Re-indication of the UL Listed Mark on Some MELSEC-F Series Models

FX3UC-32MT-LT-2, FX3U-64CCL, and FX3U-16CCL-M

FAM-A-0080-B

Changes in the rating plate

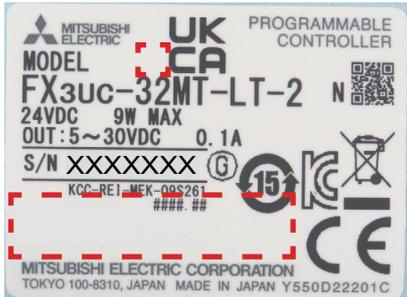
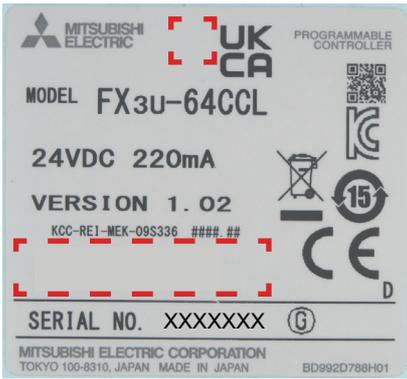
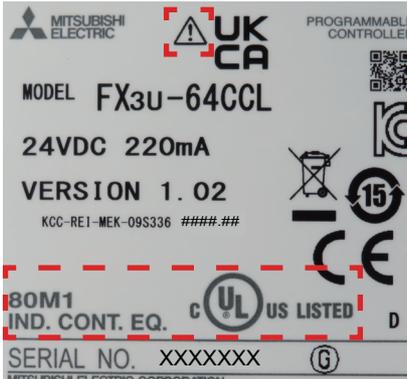
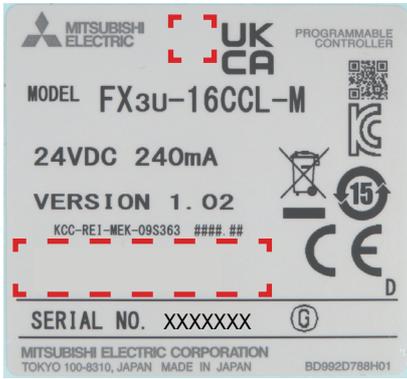
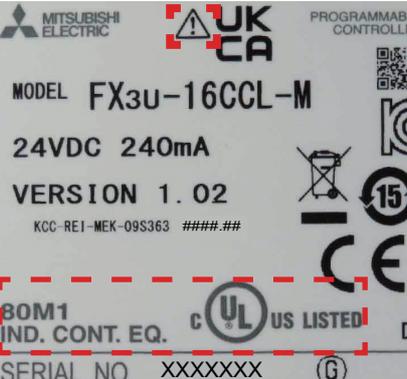
The Listed Mark and a  mark will be displayed on the rating plate as follows. In addition, the size and color of the plate will be changed.

Model	Rating plate	
	Before change	After change
FX3UC-32MT-LT-2	 <p>Height: 29mm, Width: 39mm</p>	 <p>Height: 29mm, Width: 39mm</p>
FX3U-64CCL	 <p>Height: 40mm, Width: 43mm</p>	 <p>Height: 43mm, Width: 44mm</p>
FX3U-16CCL-M	 <p>Height: 40mm, Width: 43mm</p>	 <p>Height: 43mm, Width: 44mm</p>

Change of indication for the grounding terminal

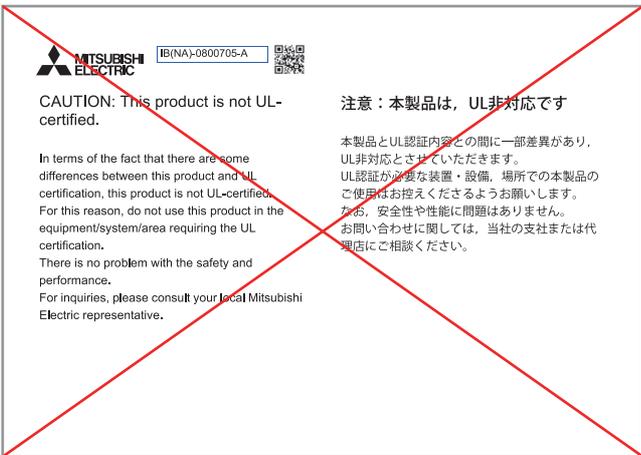
The indication for the grounding (functional grounding) terminal of power terminal block will be changed as follows.

Model	Under the top cover	
	Before change	After change
FX3U-64CCL		
FX3U-16CCL-M
